## **Product Change Notification**

December, 2016

## Bourns® Model FB2000 Series Wide-Band Chokes Change to Core Design

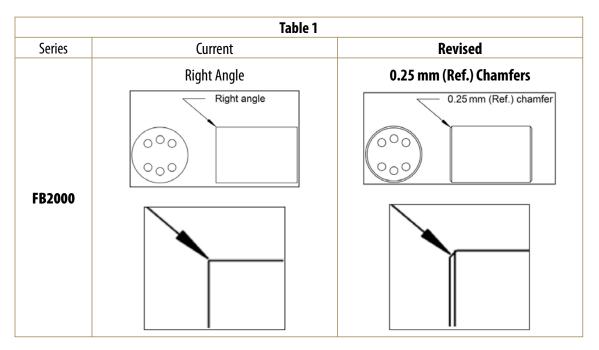
Bourns has changed the core design of the Model FB2000 Series Wide-Band Chokes starting with the manufacturing date code 1629. Chamfers are included at both ends of the core to reduce the possibility of material chipping during production assembly. See Table 1 for details.

This core modification will not affect the form, fit or function of the wide-band choke. However, the quality and reliability of the component should be enhanced.
